INFORMATION REQUEST RESPONSE

PROPOSAL: Development Permit for a Reconfiguration of a Lot (Code Assessment).

SITE ADDRESS: 17 Courtney Drive, Upper Coomera – Lot 182 on RP156422

Information Request Response	
Report Dated 28 February 2023	Revision: REV 1
Council File Reference: ROL/2023/1

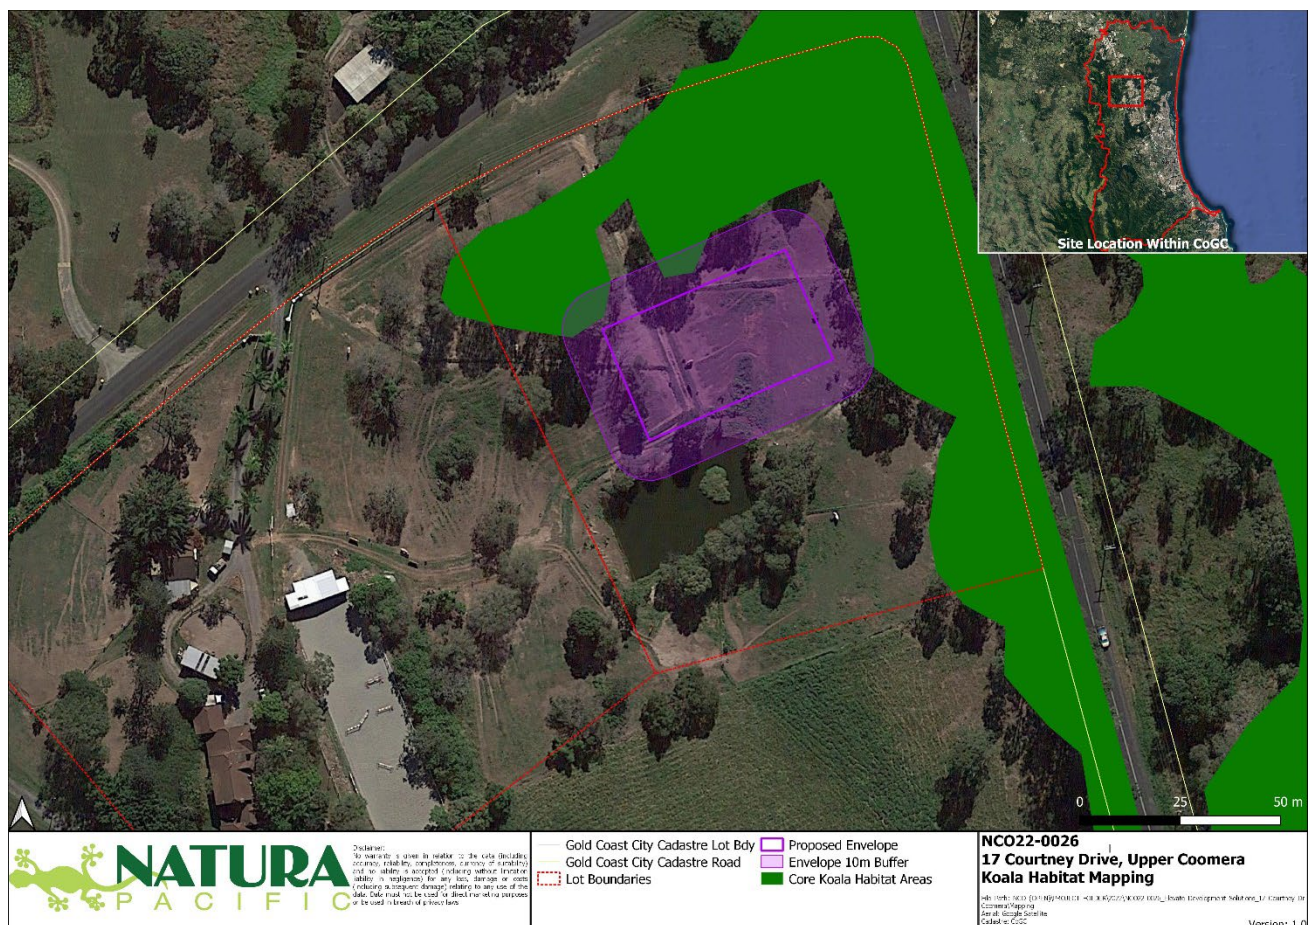
- a. *A nominated building envelope for Lot 2 with the inclusion of associated impacts (i.e., effluent and bushfire mitigation). It is recommended that the nominated building envelope avoids mapped matters of environmental significance and mapped state koala habitat. The building envelope must be responsive of setback requirements of the Rural residential zone with the consideration of the future road upgrades.*

- The Proposal Plan has been amended to reflect a nominated building envelope which avoids mapped matters of environmental significance and mapped state koala habitat.
- Additional mapping is provided below by Natura Pacific, further showcasing where the development parcel is in relation to Core Koala Habitat, highlighting that the building envelope is **outside** identified core habitat.
- A referral to the State Assessment and Referral Agency (SARA) has been facilitated.

Proposal Plan
17 Courtney Drive
Upper Coomera

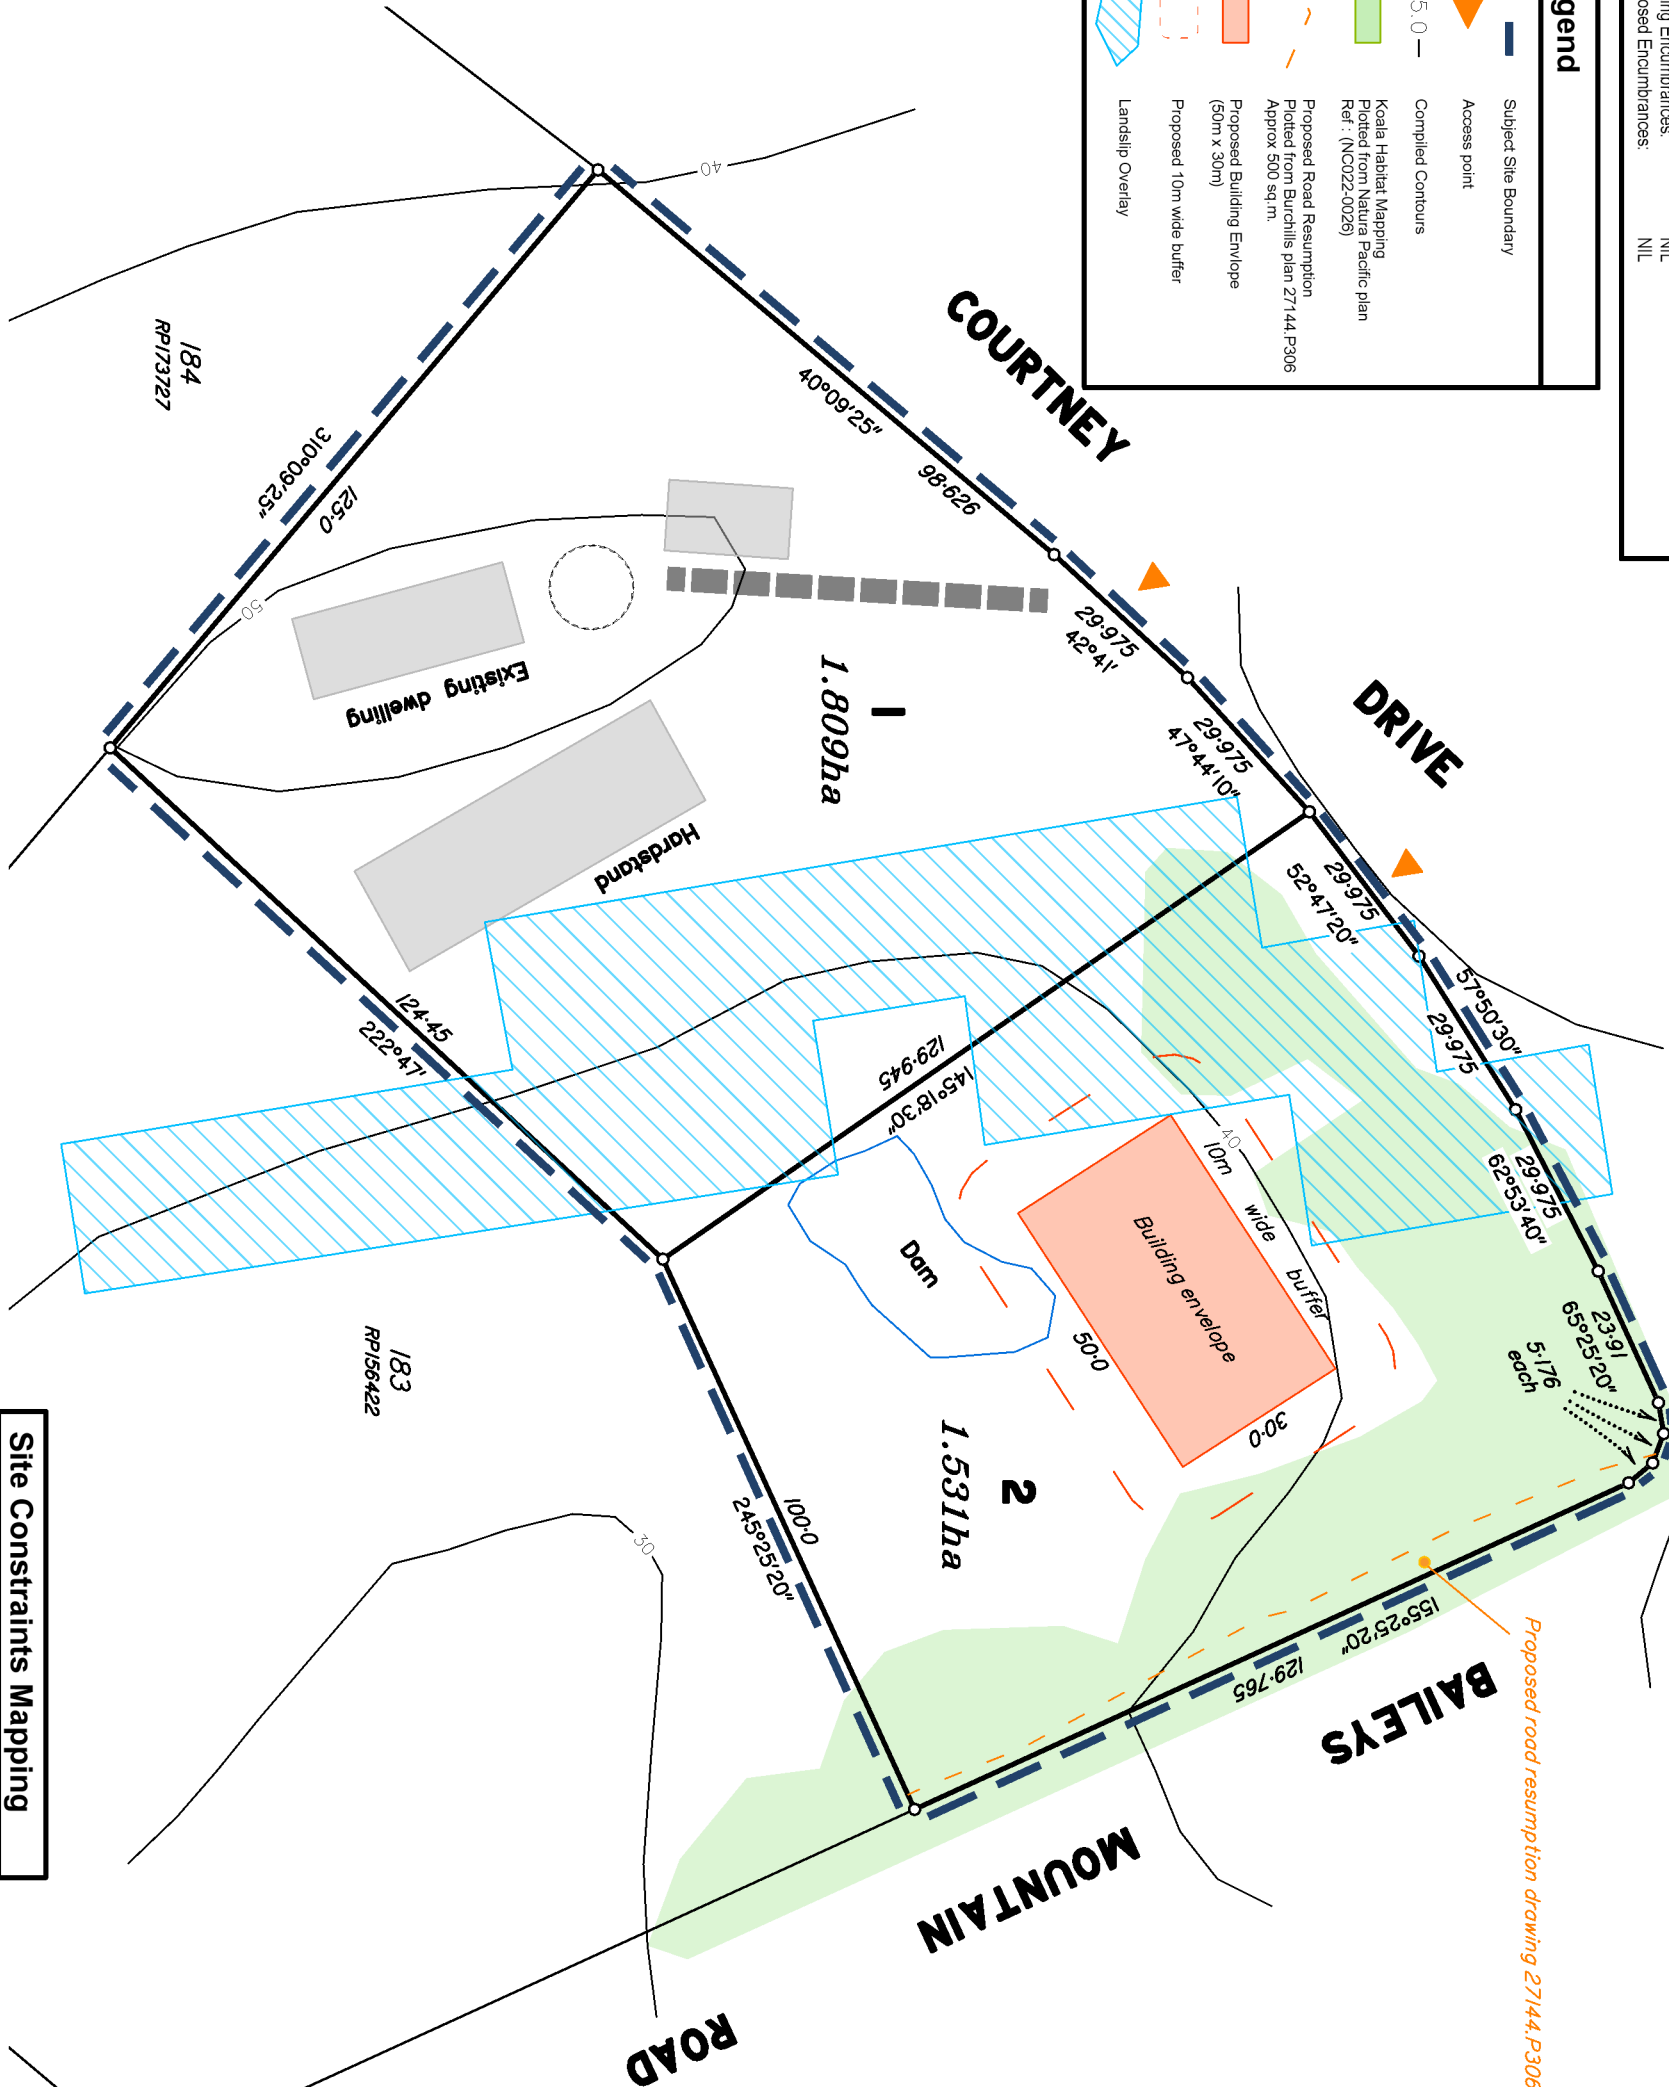
City officers request the applicant to amend the plan titled Proposal Plan by Trilogy Survey Solutions to remove any reference to existing structures on Proposed Lot 1.

Landslide Hazard Overlay Map of the City Plan identifies the site with a 'Moderate' hazard rating. As such, the relevant 'Landslide Hazard Overlay Code' is applicable. To satisfy Performance outcome PO1 and Performance outcome PO5 of the Landslide hazard overlay code, the applicant is requested to provide a geotechnical report from a Registered Professional Engineer of Queensland (RPEQ) specialising in geotechnical engineering addressing the following issues in accordance with SC6.10 City Plan policy - Geotechnical stability assessment guidelines.

To demonstrate compliance with the identified assessment benchmarks, the applicant is requested to submit amended plans demonstrating that the full frontage of the Courtney Drive frontage will be upgraded to a 'Rural Residential Collector Street' classification. The new kerb & channel shall be installed at 3.75m measuring from the centre of existing pavement. In addition, existing pavement shall be upgraded to 'Rural Residential Collector Street' classification (including surface) from the existing centre of pavement to new kerb & channel at the full frontage (subdivision side only).

In this instance, the applicant is required to submit an amended ROL Plan to reflect areas of parcel B within the site as outside of the proposed building setback areas. In addition, indicative vehicle access point for Proposed Lot 2 should be as close as possible to the proposed common boundary of both Proposed Lots 1 and 2.

In response to **item 1**, reference to the existing structures on Lot 1 have not been removed for the following reasons:

- The site plan 'Proposal Plan' has been amended to reflect which parts of the site are identified by the Landslide Hazard Overlay. The proposed building envelope is shown on these plans as **outside** identified areas.

- Proposal Plan has been amended to show which aspect of the site is impacted by upgrades to Bailey Mountain Road as per Proposed Road Resumption drawing 27144.P306.
- Proposal Plan has been amended to show that the vehicle access point for Proposed Lot 2 is as close as feasible to the common boundary of both Proposed Lots 1 and 2.
- Following discussions with the Traffic and Transport team, it was confirmed the proposed land resumption will be compensated via a Transport Network Infrastructure offset against the levied charges on the Infrastructure Charge Notice.
